MLRB Permit M-77-534 comments on Golden's Oct. 1 letter Technical Revision No. 4;

To: Peter Hays, MLRB Permit M-77-534, Technical Revision No. 4;

**Evaluation Report
Review Reclamation on the
Guanella Ranch**

Photo 1. Area to be changed as proposed in the Technical Revision,

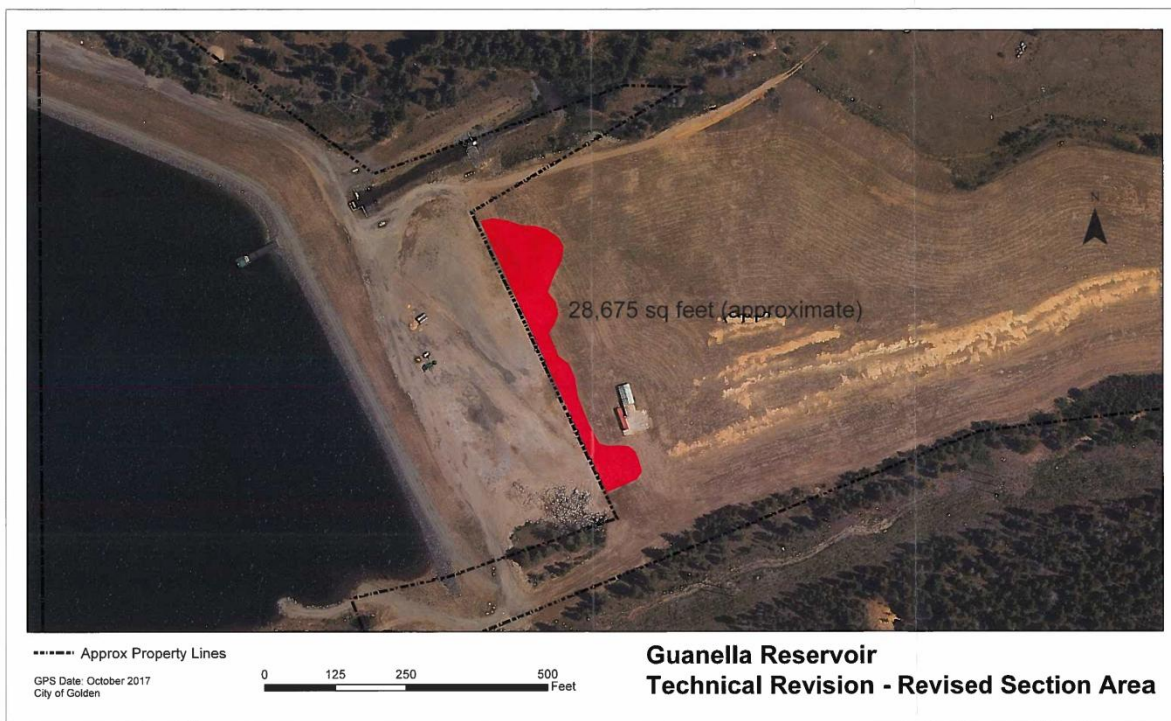
Golden is proposing to remove saline soils on 28,675 ft² (0.66 acres, 2/3 acres) to a depth of 18 inches on the southwest side of the pit adjacent to the reservoir dam (see Photo 1 copied from the TR application to DRMS). Twelve inches of clay subsoil will then be applied topped with six inches of topsoil.

There are several concerns with this approach to reclamation and revegetation on this alluvial terrace along Clear Creek. The six inches of topsoil is inadequate to support pasture land vegetation since the original topsoil and viable subsoil was 13 to 20 inches thick with abundant roots and organic matter (Unit 27, Lone Rock-Breece, gravelly sandy loam, USRCS 1983, Empire, Colorado soil survey). The shallow low permeability clay subsoil will restrict root growth, and reduce plant productivity. The site will not support rangeland pasture, and allow grazing.

As stated earlier the proposed TR changes to the salt contaminated soils are inadequate to support native productive vegetation.

Photo 3. Salt and sand onsite in 2009.

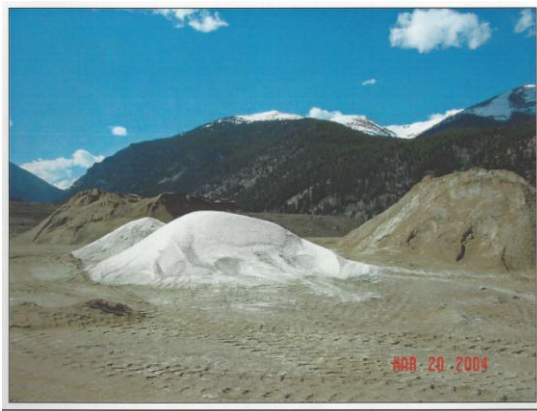
Salt and other road material (asphalt) were stored onsite, and used for road construction and sanding roads in winter. Photo 3 shows the salt and sand stored onsite during operations, and Photo 4 shows salt being buried onsite.
